January 30, 2015

RE: PLUS review 2014-09-05, Caesar Rodney School District New Elementary School

Response to PLUS Review 2014-10-22

Figure 1: NRCS soil survey mapping update in the vicinity of the proposed project

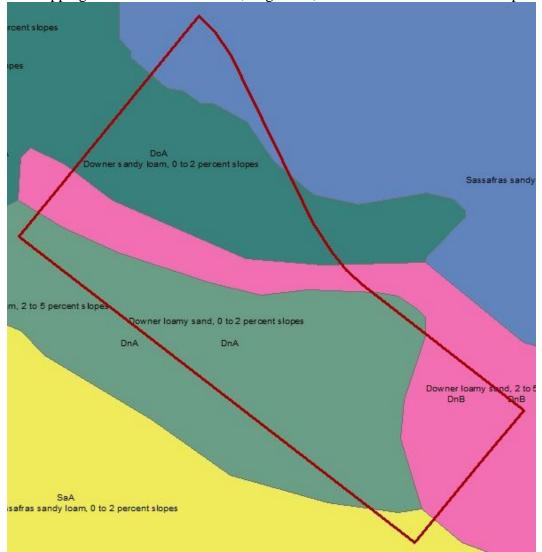
• Based on soils survey mapping update, the soil mapping unit(s) mapped is Downer. This soil mapping unit is well drained and, in general, has few limitations for development.
